Access Compliance Report

Public Rights-of-Way

(Curb Ramps)

Intersection ID: 24374	Main Street: BEVERLY_CREST_BV	Cross Street: PINEVILLE-MATTHEWS_RD	Location: NW
ADA ID: A7C82201686D	Ramp Type: Perp	Initial Pass/Fail: Fail	Overall Compliance: No
		Severity Score: 37.5

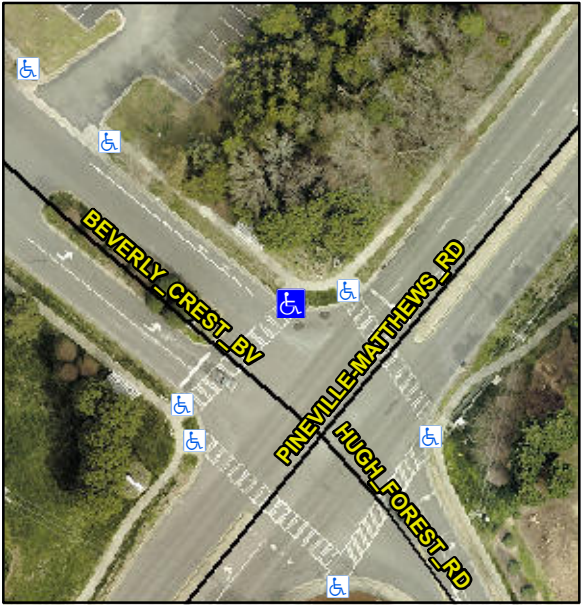
Codes/Mitigation Info/Possible Solution			Field Measurements/Component Compliance		
	Possible Solutions:		Compliance	Description	Data
	Remove & Replace Entire Ramp.		No	Ramp Length (in)	101.0
			Yes	Ramp Width (in)	60.0
			N/A	Flare Type LT	N/A
			N/A	Flare Slope LT (%)	N/A
			N/A	Flare Traversable LT?	N/A
			N/A	Landing Length (in)	N/A
			N/A	Landing Width (in)	N/A
			N/A	Landing Slope (%)	N/A
			N/A	Landing X Slope (%)	N/A
<p>Surveyor Notes:</p> <p>N/A</p> <p>PROW/ADA:</p> <p>Not Found, R304.2.2, R304.5.3</p>			N/A	Flare Type RT	N/A
			N/A	Flare Slope RT (%)	N/A
			N/A	Flare Traversable RT?	N/A
			N/A	DWS Provided?	N/A
			N/A	DWS Contrast?	N/A
			N/A	DWS Length (in)	N/A
			N/A	DWS Full Width?	N/A
			N/A	DWS Offset (in)	N/A
			N/A	Gutter Ponding?	N/A
			N/A	Gutter Lip Ht (in)	N/A
<p>Total Cost:</p> <p>\$ 1850.00</p>			Yes	Painted X Walk1?	N/A
			N/A	X Walk 1 Direction	To SW
			N/A	X Walk 1 Width (in)	117.0
			N/A	X Walk 1 Slope (%)	3.3

N/A	X Walk 1 X Slope (%)	6.8
			N/A	Ramp inside XWalk1?	Yes
			N/A	Road Slope (%)	N/A
			N/A	Road X Slope (%)	N/A
			N/A	Any Obstructions?	N/A
			N/A	Obstruction Type	N/A
			N/A	Clear Space?	N/A
			N/A	Clear Space to XWalk (in)	N/A
			N/A	Storm Grate/Utility Hazard?	N/A
			N/A	Storm Grate/Utility Type	N/A
			Yes	Surface Condition? (G/P)	Good
